Previous Technical Bulletins

AC 005 CHANGE TO TECHNICAL CODE - 817824

Vehicles: PSA Vehicles

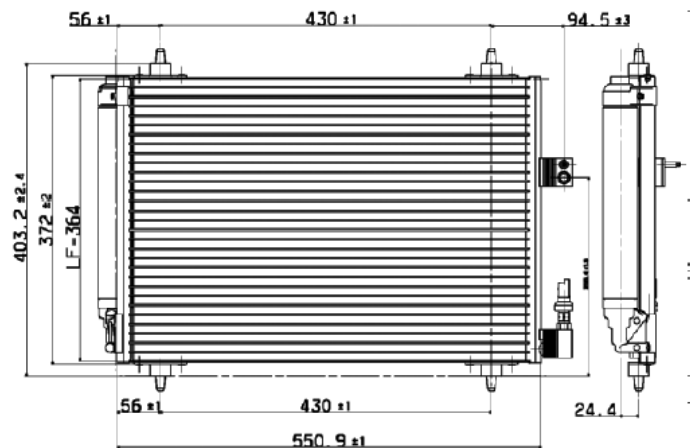
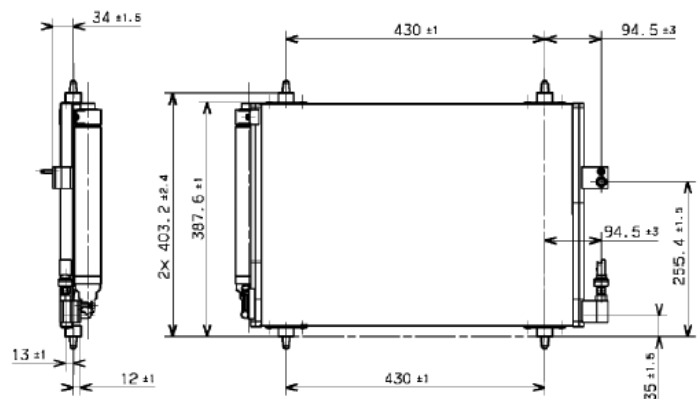
The condenser fitted to the following PSA vehicles, with technical reference code CA1542, measures 3mm less in width to 817824 (CA1458).

Valeo Service can confirm that both condensers are interchangeable. 817824 reference is maintained but technical code CA1458 is replaced by CA1542.
